Groundwater Application Review Summary Form

Application # G- 18854

TO: Water Rights Section Date 9/23/2019
 FROM: Groundwater Section Travis Brown
 Reviewer's Name
 SUBJECT: Application G- 18854 Supersedes review of _____
 Date of Review(s)

A. GENERAL INFORMATION: Applicant's Name: Carol Lee County: Marion

This Drawdown Analyses

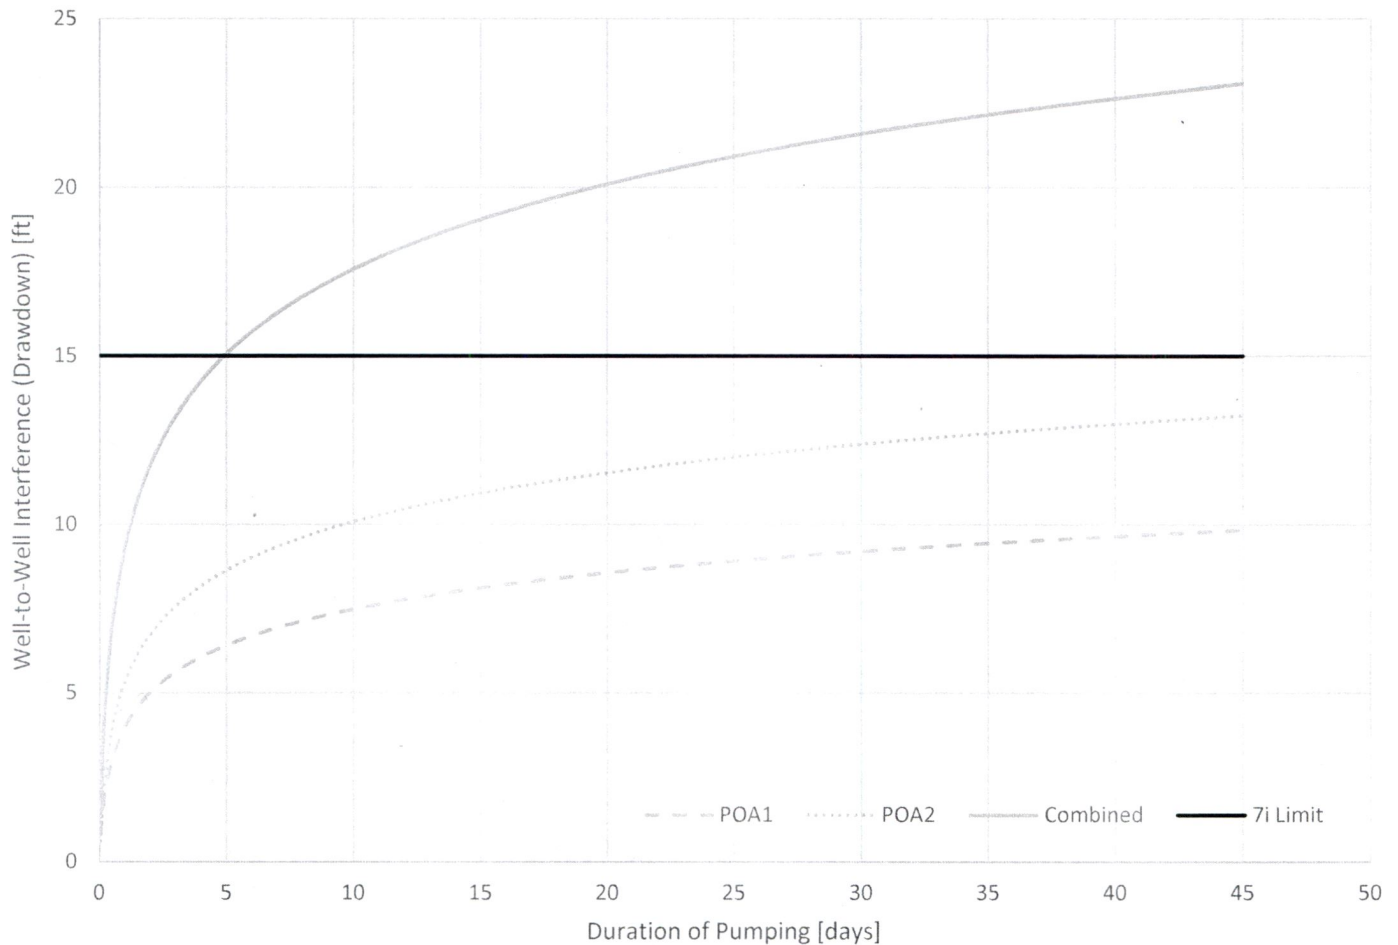
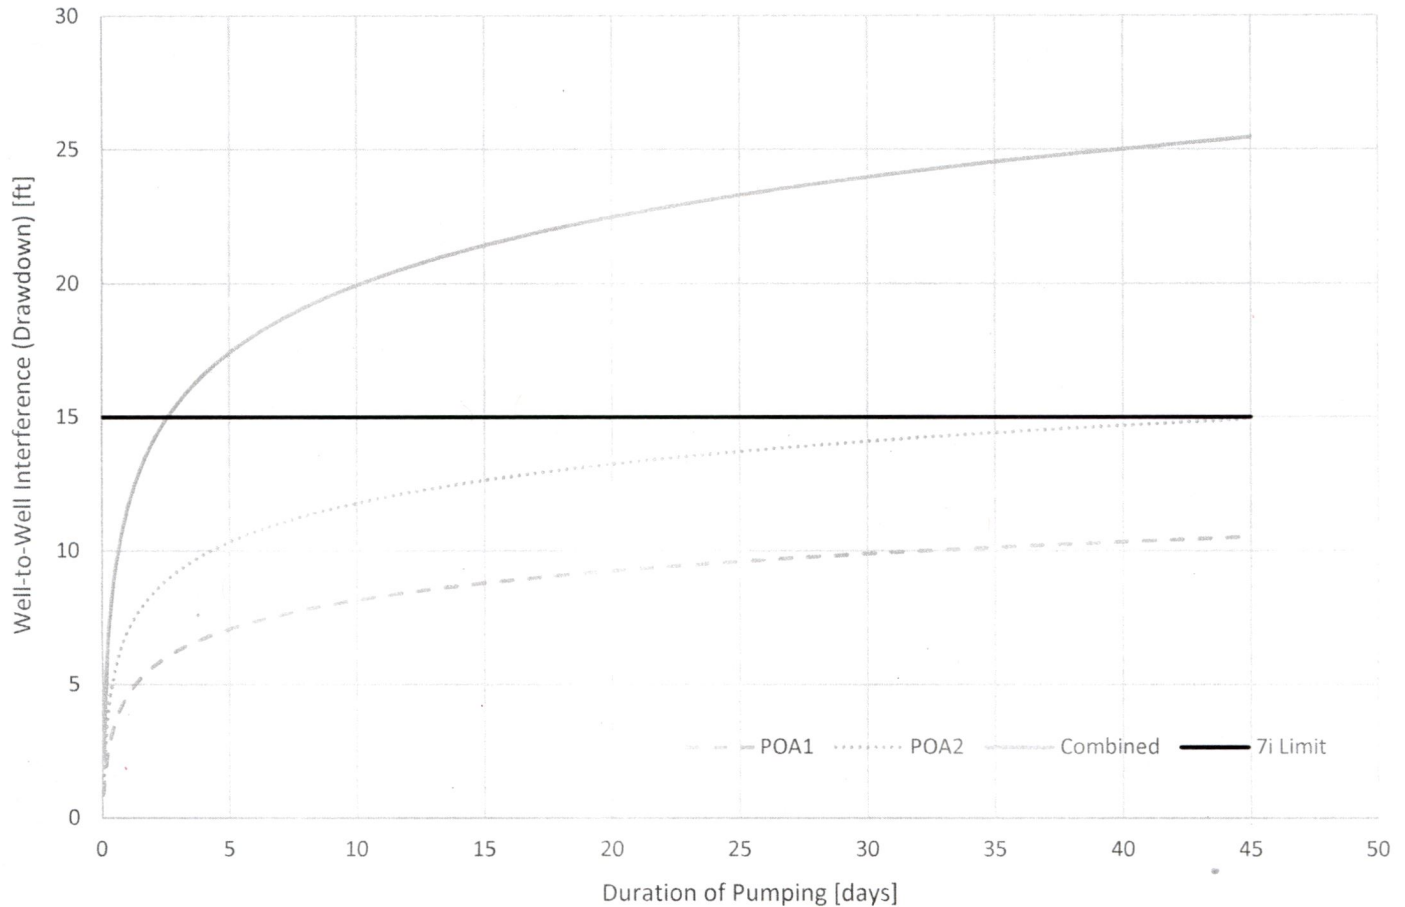
The nearest groundwater users to the proposed POA are MARI 63710, ~280 ft northwest of POA 1 and ~670 ft southwest of POA 2, and MARI 59485, ~500 ft east of POA 1 and ~570 ft south of POA 2. Both MARI 63710 and MARI 59485 are exempt domestic wells. To assess the degree of drawdown, analyses were conducted for the proposed use using the Theis equation for drawdown in a confined aquifer (see attached Theis Drawdown Analyses). **Results indicate that the proposed use could cause well-to-well interference with MARI 63710 and MARI 59485 to exceed 15 ft of drawdown within less than 1 week of continuous operation at the maximum proposed rate (0.0935 cfs or ~42 gpm), which would require curtailment of**

the proposed use per Condition 7i, above. Therefore, it would appear that groundwater for the proposed use will not likely be available in the amounts requested without injury to prior water rights.
